**CITY OF SAINT PAUL
HERITAGE PRESERVATION COMMISSION STAFF REPORT**

FILE NAME: 962 Summit Avenue
DATE OF PRE-APPLICATION: February 3, 2020
APPLICANT: John Sharkey, Sharkey Design Build
DATE OF HPC MEETING: February 24, 2020
HPC SITE/DISTRICT: Historic Hill Heritage Preservation District
LEGAL DESCRIPTION: Lot 10 and the east 20 feet of Lot 11, Block 27, Summit Park Addition to St. Paul
PERIOD OF SIGNIFICANCE:
NRHP: Historic Hill District
SRHP: Historic Hill District
CLASSIFICATION: New Construction
ZONING: R2 **WARD:** 2 **PLANNING DISTRICT:** 16 – Summit Hill Association
STAFF INVESTIGATION AND REPORT: Christine Boulware
DATE: February 18, 2020

CERTIFICATE OF SURVEY

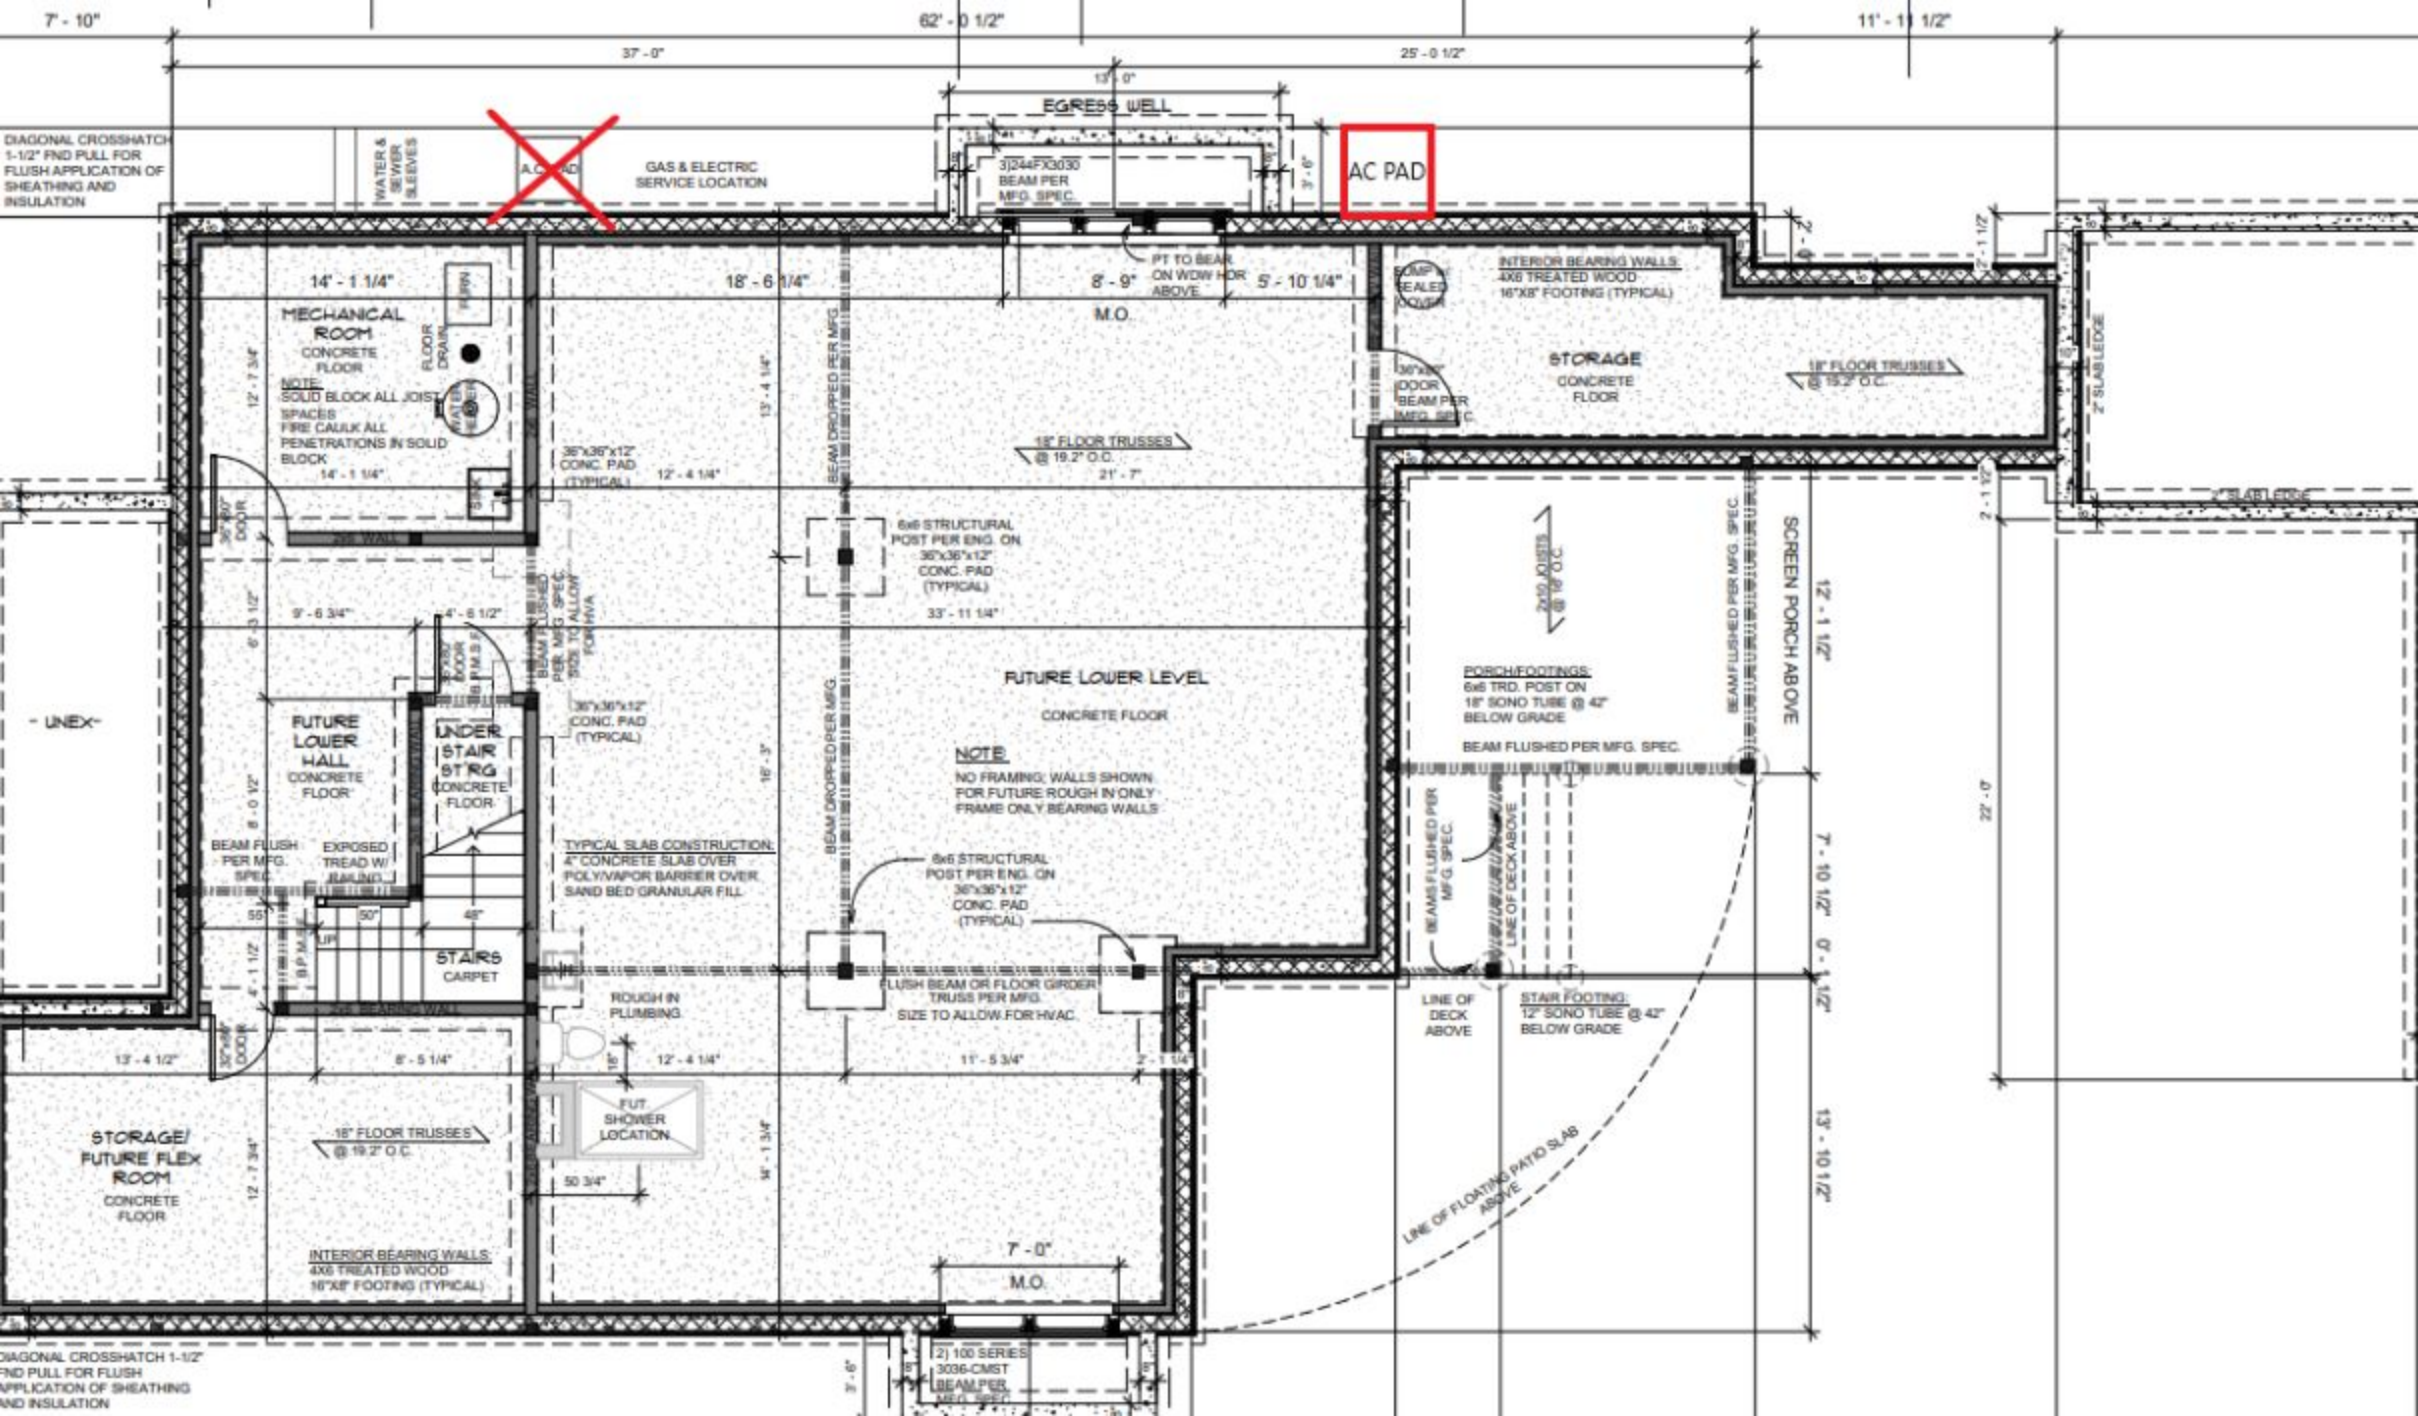
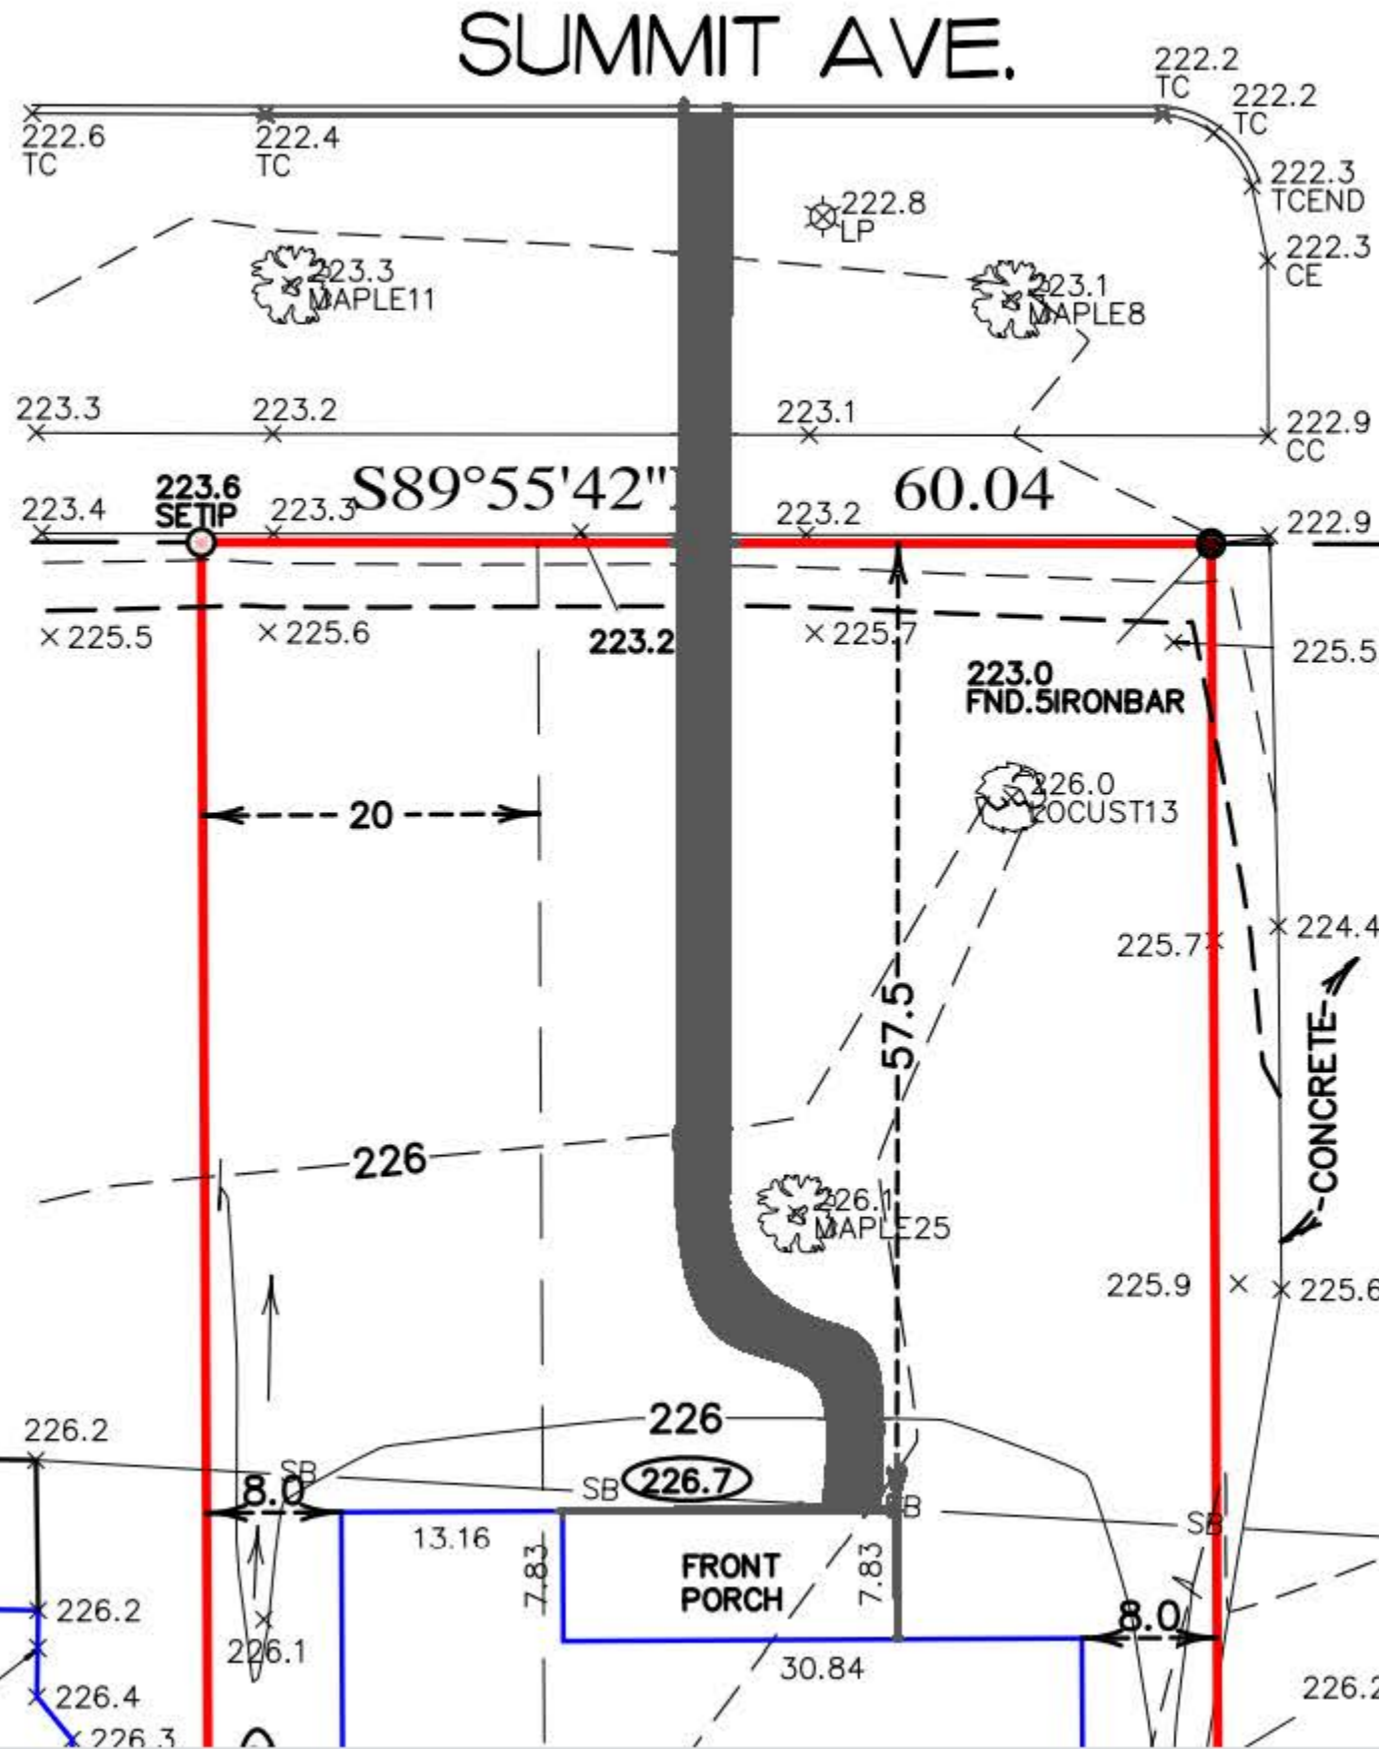
<p>(f) Site:</p>		
<p>(f)(1) Setback. New buildings should be sited at a distance not more than five (5) percent out-of-line from the setback of existing adjacent buildings. Setbacks greater than those of adjacent buildings may be allowed in some cases. Reduced setbacks may be acceptable at corners. This happens quite often in the Historic Hill area and can lend delightful variation to the street.</p>	<p>No</p>	<p>The new residence shall be setback slightly behind the front facades of the adjacent historic dwellings to allow them to retain their historic rhythm along the block-face.</p>
<p>(f)(2) Landscaping:</p> <p>a. Typically, open space in the Historic Hill District is divided into public, semipublic, semiprivate and private space. The public space of the street and sidewalk is often distinguished from the semipublic space of the front yard by a change in grade, a low hedge or a visually open fence. The buildings, landscaping elements in</p>	<p>Not enough information</p>	<p>The transition of space, hardscaping and fencing will be reviewed at the public hearing. The HPC may give feedback here. It is important to point out that a new sidewalk within the boulevard will kick in parkland diversion. The HPC has not required new construction</p>

<p>(f)(3) Garages and parking:</p> <p>a. <i>If an alley is adjacent to the dwelling, any new garage should be located off the alley. Where alleys do not exist, garages facing the street or driveway curb cuts may be acceptable. Garage doors should not face the street. If this is found necessary, single garage doors should be used to avoid the horizontal orientation of two-car garage doors.</i></p> <p>b. <i>Parking spaces should not be located in front yards. Residential parking spaces should be located in rear yards. Parking lots for commercial uses should be to the side or rear of commercial structures and have a minimum number of curb cuts. All parking spaces should be adequately screened from the street and sidewalk by landscaping. The scale of parking lots should be minimized, and the visual sweep of pavement should be broken up by use of planted areas. The scale, level of light output</i></p>	<p>Yes</p>	<p>The garage and driveway are located off the alley; this complies with the guideline.</p>

Double-Hung Window

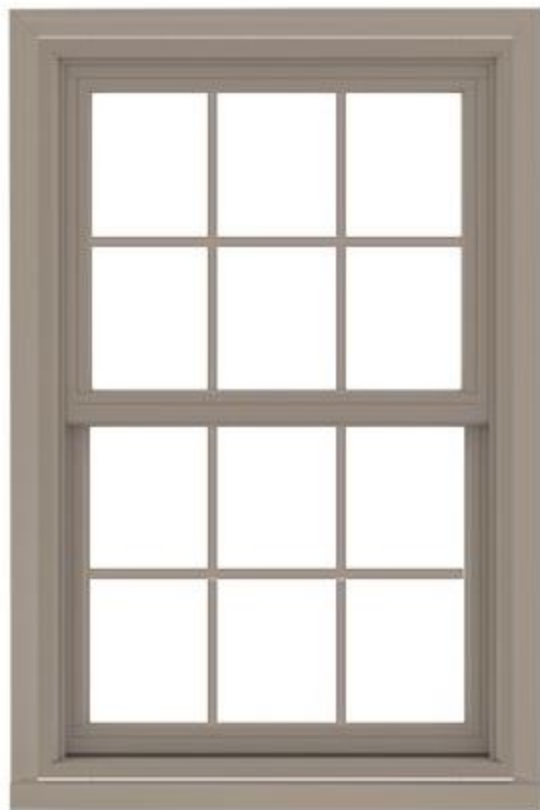
<p><i>c. Roof hardware such as skylights, vents and metal pipe chimneys should not be placed on the front roof plane.</i></p>		
<p>(e)(2) Windows and doors: <i>a. The proportion, size, rhythm and detailing of windows and doors in new construction should be compatible with that of existing adjacent buildings. Most windows on the Hill have a vertical orientation, with a proportion of between 2:1 and 3:1 (height to width) common. Individual windows can sometimes be square or horizontal if the rest of building conveys the appropriate directional emphasis. Façade openings of the same general size as those in adjacent buildings are encouraged.</i> <i>b. Wooden double-hung windows are traditional in the Historic Hill District and should be the first choice when selecting new windows. Paired casement windows, although not historically common, will often prove acceptable because of their vertical orientation. Sliding windows, awning windows, and horizontally oriented muntins are not common in the district and are generally unacceptable. Vertical muntins and muntin grids may be acceptable when compatible with the period and style of the building. Sliding glass doors should not be used where they would be visible from the street.</i> <i>c. Although not usually improving the appearance of building, the use of metal windows or doors need not necessarily ruin it. The important thing is that they should look like part of the building and not like raw metal appliances. Appropriately colored or bronze-toned aluminum is acceptable. Mill finish (silver) aluminum should be avoided.</i></p>	<p>Not enough information</p>	<p>The proportion, size, rhythm and details of windows and doors appears to be compatible those in existing adjacent buildings; they are double-hung and vertically oriented. The window muntins should have both interior and exterior profiles (no snap-in or grid-between-glass). The proposed windows are wood with a vinyl-clad exterior; so long as the window details and proportions are historically appropriate and the clad finish is a darker color, the proposal will meet the intent of the guideline.</p>
